**Subject: Supplemental Information to US-APWR DCD RAI No. 92-1237 Revision 0**

Docket No. 52-021  
MHI Ref: UAP-HF-09137

Supplemental Information to US-APWR DCD RAI No. 92-1237  
Revision 0

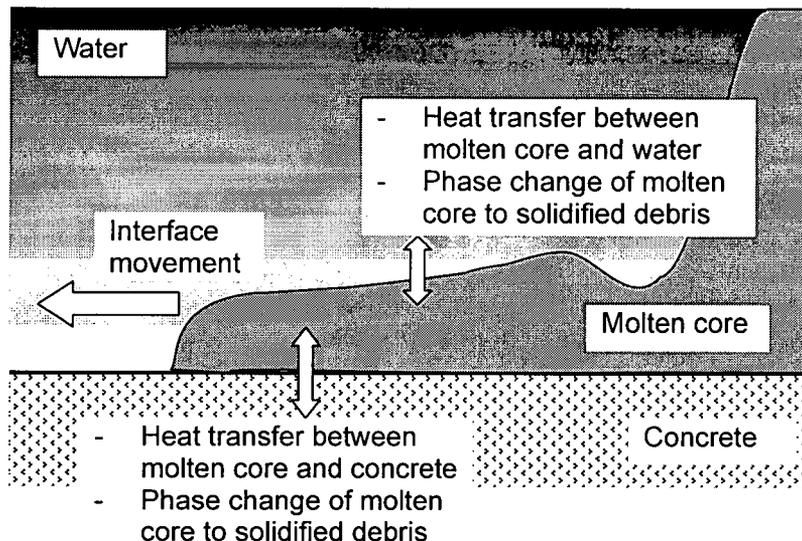
The NRC staff requested MHI to demonstrate the basis for use of FLOW-3D by reference of test, etc.

In the answer to Question 19-161 of RAI#19-1237, three requirements to model debris spreading behavior were presented, i.e.:

- Ability to evaluate interface movement of molten core
- Ability to evaluate solidification process of molten core
- Ability to evaluate temperature profile of molten core

Fundamental physical characteristics to be solved during the spreading process of molten core are all included in these three abilities as depicted in the schematic drawing below.

In order to validate the capability of FLOW-3D code to solve the problem of molten core spreading behavior, MHI referenced two types of studies, one is casting experiment and analysis (three casting studies are referenced in "Answer to additional item (a)", page 19-161-3 to 5), and the other is thermal transportation experiment and analysis (i.e. MINI-ACOPO experiment). The casting study covers areas of interface movement and solidification process of molten core; and the thermal transportation study covers an area of temperature profile of molten core.

From these two types of studies, it has been confirmed that FLOW-3D has adequate capability to evaluate the molten core spreading process for the US-APWR design.
